Los Alamos
NATIONAL LABORATORY
EST. 1943

Date: OCT 25 2011
Refer To: EP2011-0344

Subject: Rationale to Plug and Abandon Borehole SCI-3

Figure 1. Correlation of Tb4 and groundwater occurrences in well SCI-2 and borehole SCI-3

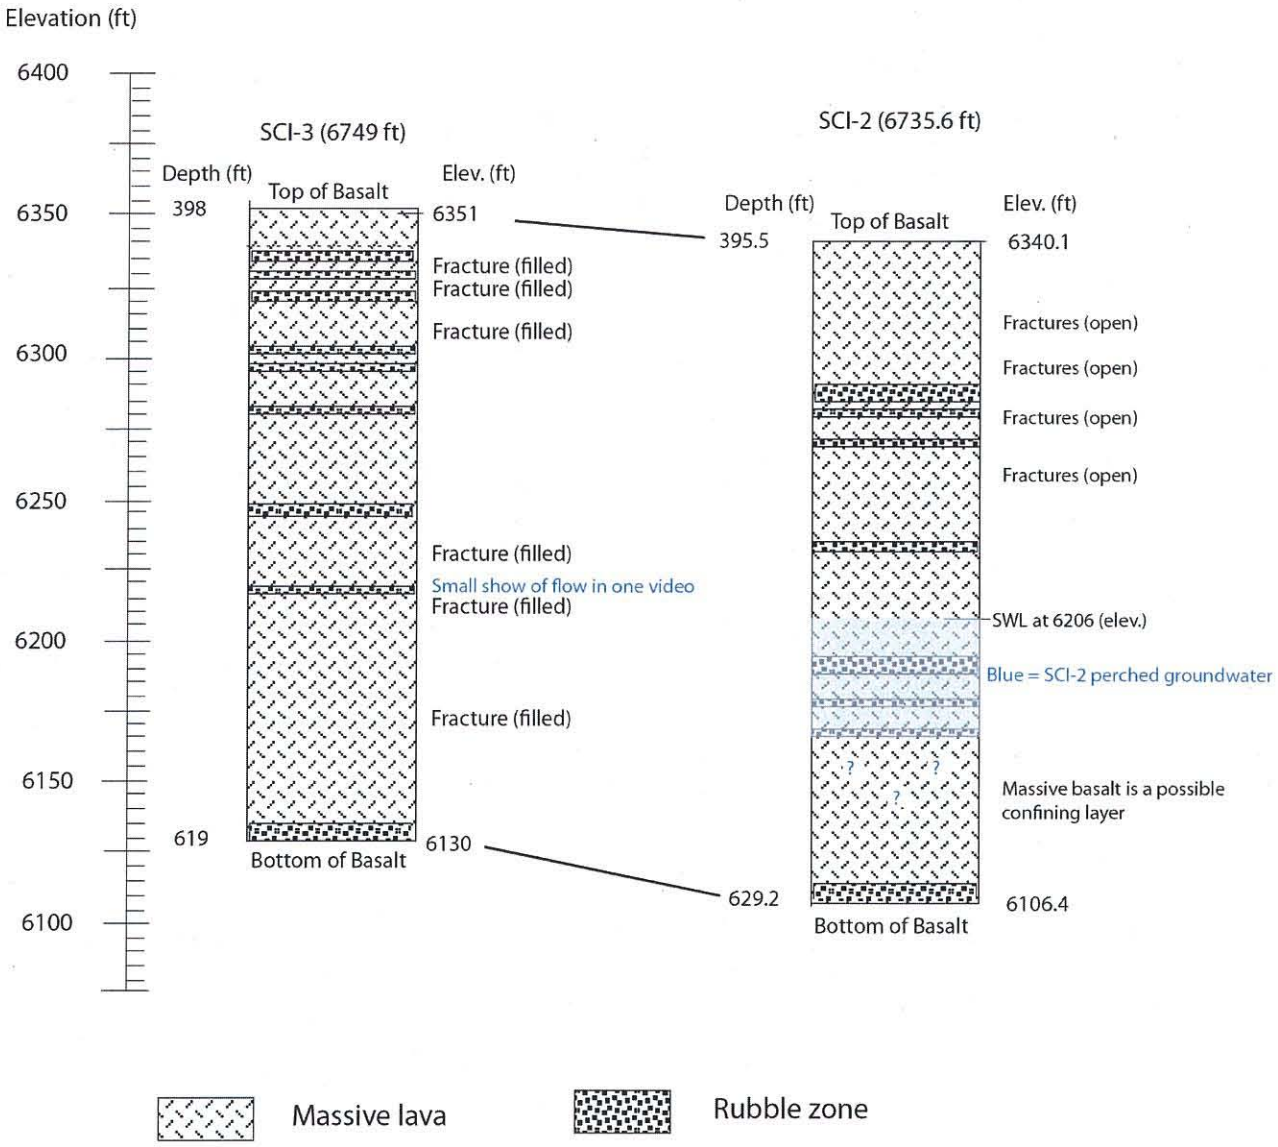
Comparison of the Tb4 in SCI-2 and SCI-3 shows the lowermost massive lava is much thicker at SCI-3 (Figure 1). Thickness variations within lava flows are common in Tb4 series and reflect substantial paleotopography during volcanism. Rubble zones are important components of porous media hosting the perched–groundwater zone at SCI-2; these rubble zones are apparently absent at similar elevations in SCI-3, but are present at the base of Tb4 at SCI-3. Therefore, it appears that hydrogeologic conditions favored the accumulation of perched water at SCI-2, but not at SCI-3.

Figure 2. The stratigraphic sequence, lithologic types, and contacts for SCI-3, along with P&A bentonite and cement placements

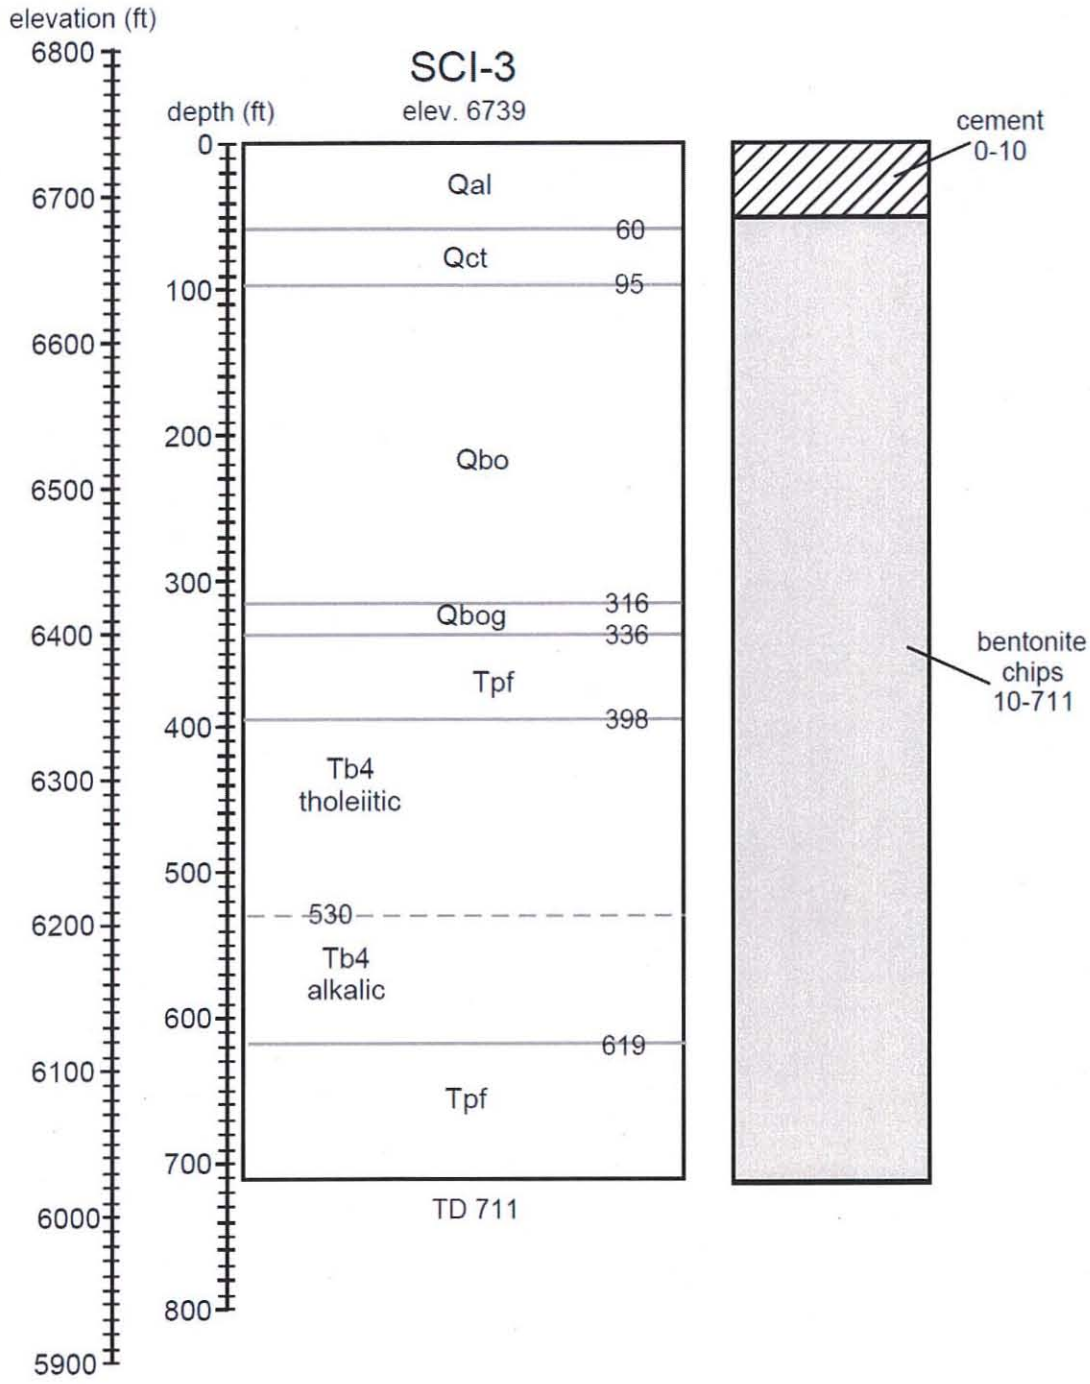
Driller's observations and video logs indicate perched saturation within Tb4 at SCI-3 is not sufficient to install a well. The upper perched zone, above Tb4, is already sampled effectively by the adjacent well SCI-1. For these reasons any perched-intermediate well design for SCI-3 would not be warranted, and therefore, the Laboratory recommends the P&A of borehole SCI-3, as shown in Figure 2.
